VILLAGES OF DEER RIVER SUBDIVISION

APPLICATION NUMBER 1 DATE January 15, 2015

REQUEST Subdivision

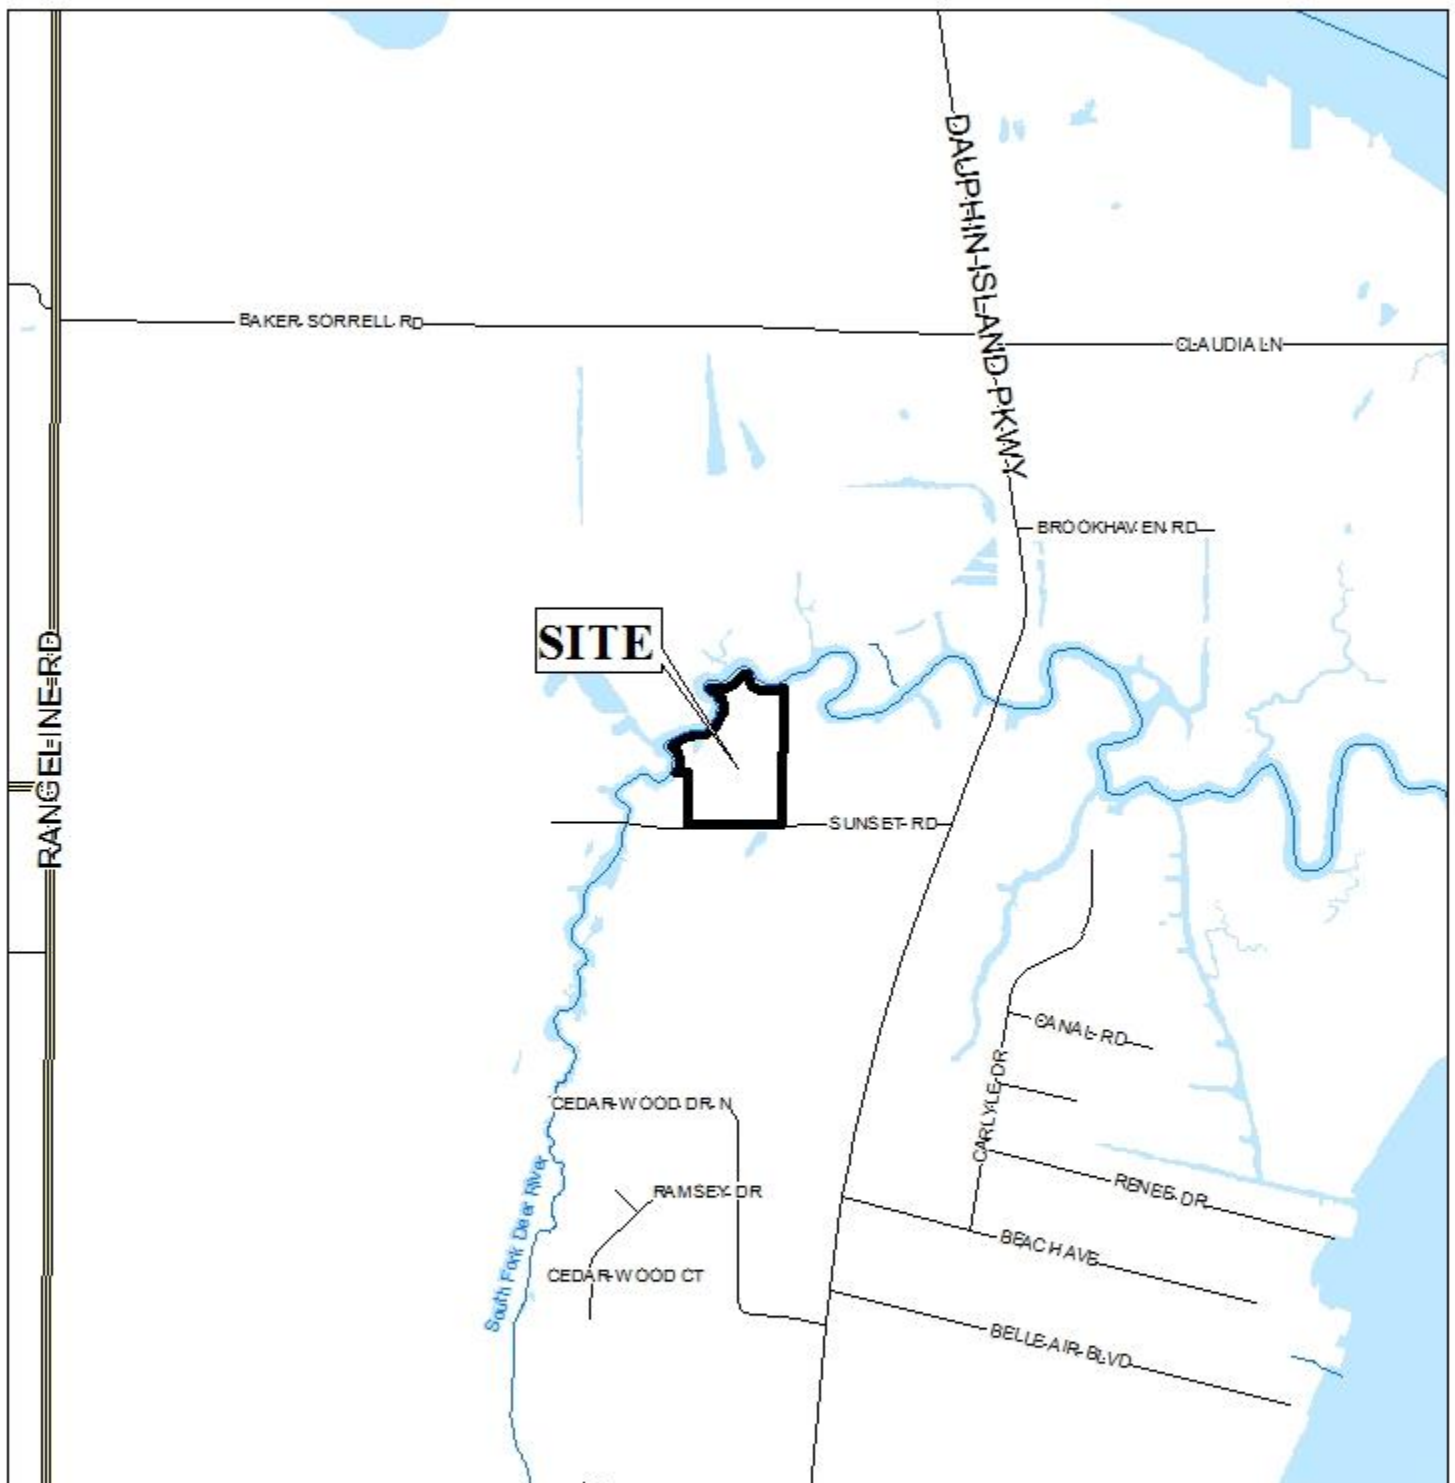
The application was heldover at the applicant's request. The applicant submitted a revised preliminary plat illustrating a 5-lot subdivision, with each proposed lot having frontage on Sunset Road.

It should be noted that all of the proposed lots exceed the standards for width-to-depth ratio. Section V.D.3. of the Subdivision Regulations states that lot depth should not exceed 3.5 times the width of the lot at the building setback. As proposed, all lots are approximately 100' wide at the building setback, and range from 500' to 835' deep.

The 25' minimum setback line is not illustrated as required by Section V.D.9. of the Subdivision Regulations. The setback should be illustrated along all frontages on the Final Plat, if approved.

- 1) *Sunset Road is a substandard, unpaved road, not meeting the minimum width or surfacing requirements of Section VIII.E.2.c. of the Subdivision Regulations, thus raising concerns regarding access to the proposed subdivision; and*
- 2) *all of the proposed lots exceed the width-to-depth ratio as stated in Section V.D.3. of the Subdivision Regulations.*
